SUNDRY NOTICES AND REPORTS ON WELLS

Corral Fly 35-26 Federal Com #31H - 30-015-44726 - NMNM88139
Corral Fly 35-26 Federal Com #32H - 30-015-44727 - NMNM88139
*Corral Fly 35-26 Federal Com #33H - 30-015-44728 - NMNM88139

OXY USA Inc. - Corral Fly 35-26 Federal Com 31H, 32H, 33H – Amended Drill Plan

5/10M BOP Stack

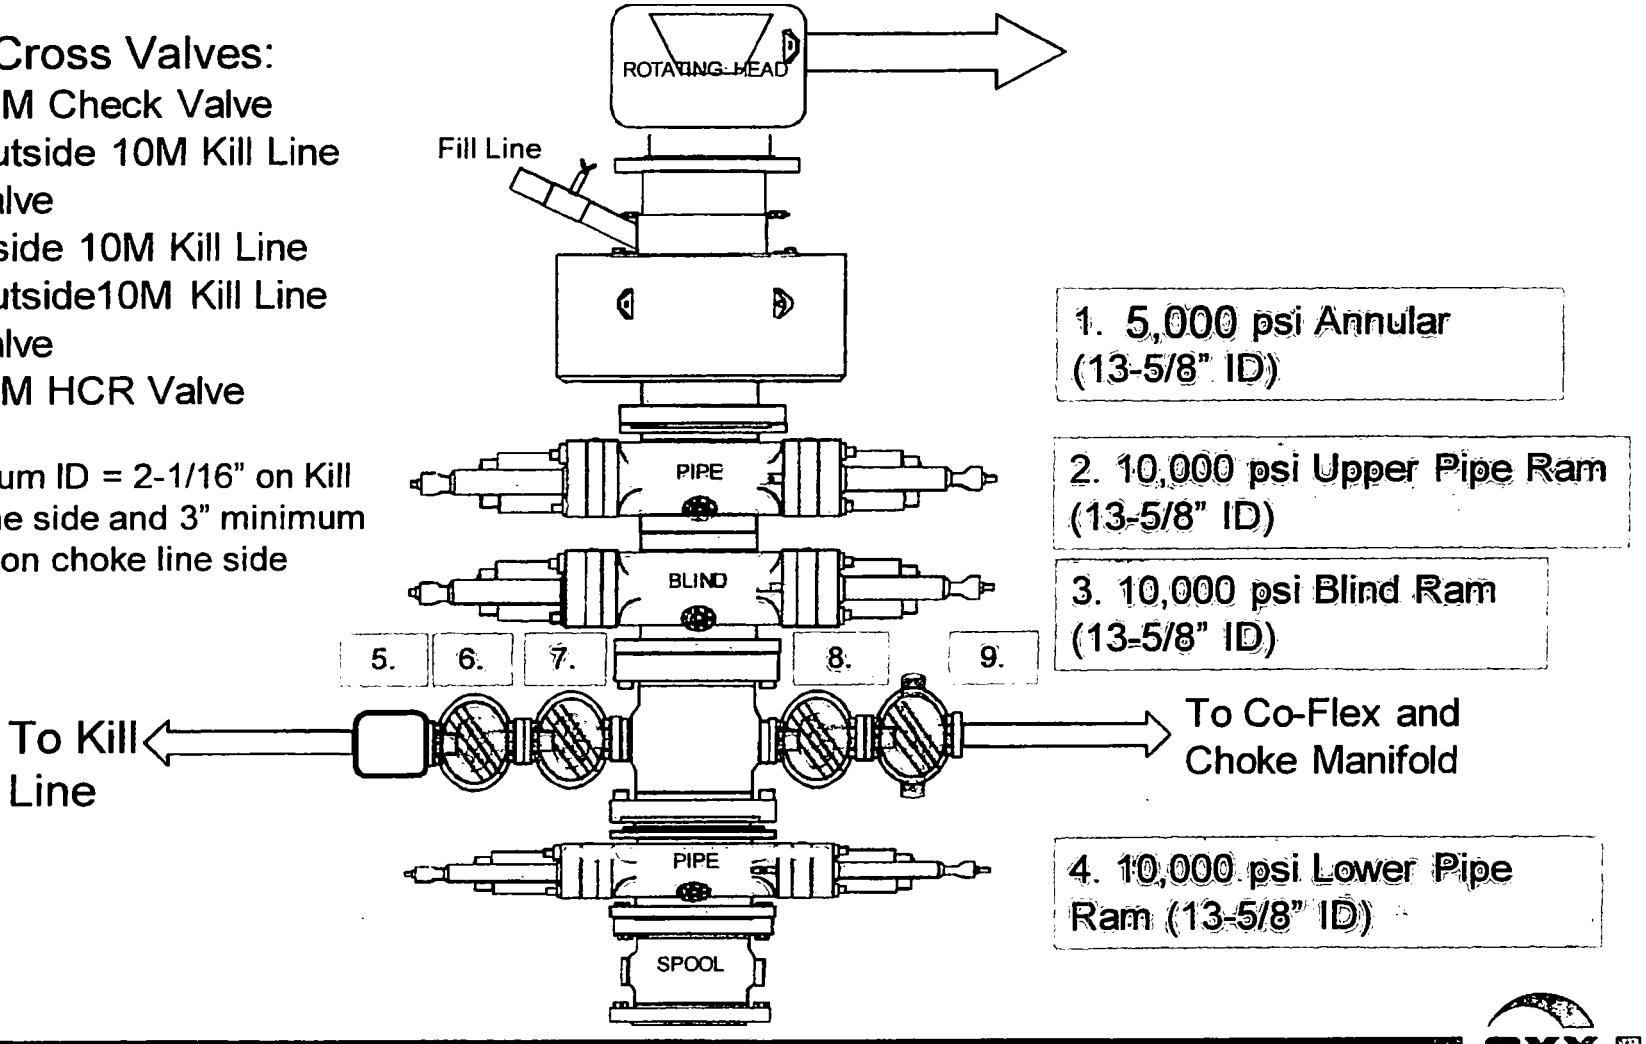
OXY respectfully requests to employ a 5M annular with a 10M BOPE stack in the lateral section of the well and will ensure that two barriers to flow are maintained at all times. Please see attached Well Control Plan.

Per BLM's Memorandum No. NM-2017-008: *Decision and Rationale for a Variance Allowing the Use of a 5M Annular Preventer with a 10M BOP Stack*, Oxy requests to employ a 5M annular with a 10M BOPE stack in the lateral section of the well and will ensure that two barriers to flow are maintained at all times. Please see attached Well Control Plan.

2. Minimum working pressure of the blowout preventer (BOP) and related equipment (BOPE) required for drilling below the surface casing shoe shall be **5000 (5M)** psi.
